Consultation for amending Acceptable Solutions and Verification Methods

July 2016

Published July 2016 by
Ministry of Business, Innovation and Employment
PO Box 10-729
Wellington 6143
New Zealand

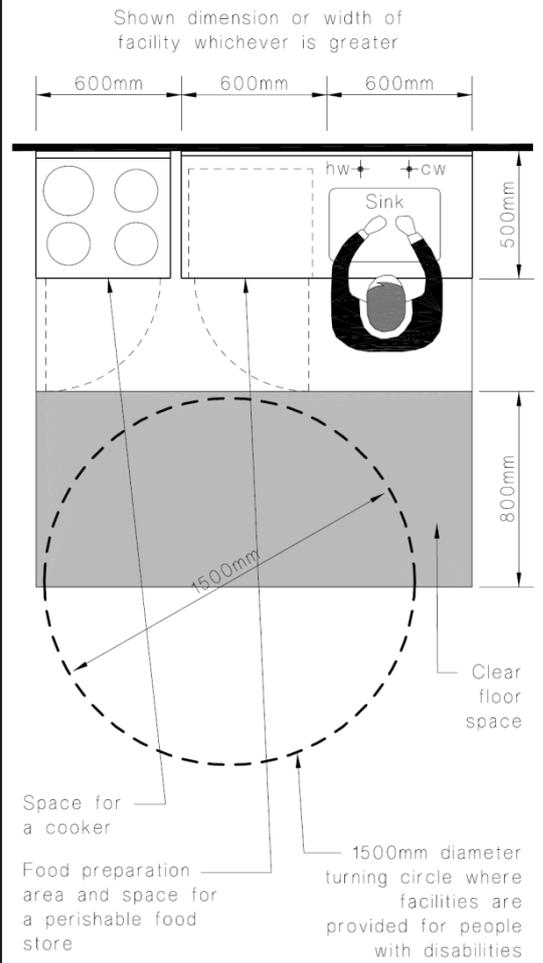
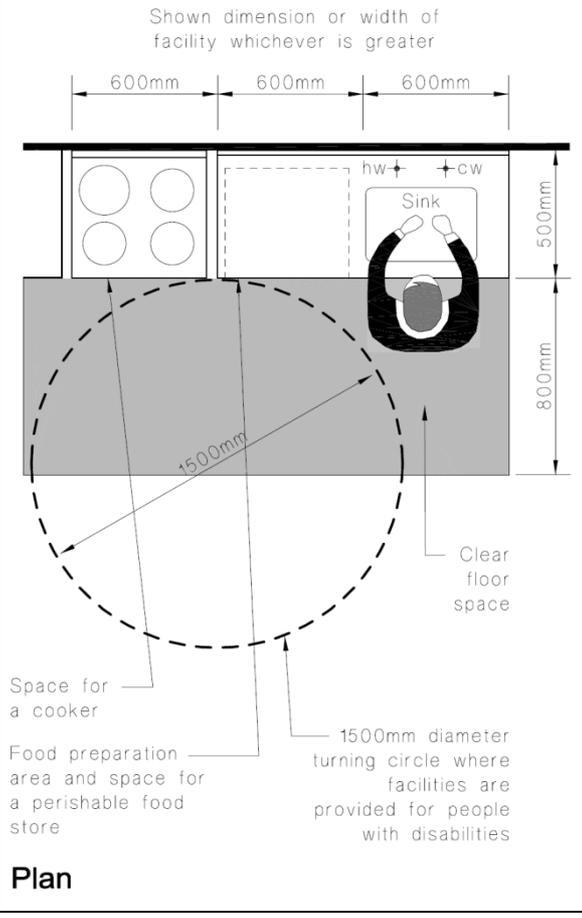
- Amend Figure 1
- Clarify requirement of the height of kitchen work surfaces for people with disabilities

Current Text	Proposed Changes
	Modify Figure 1 as shown below
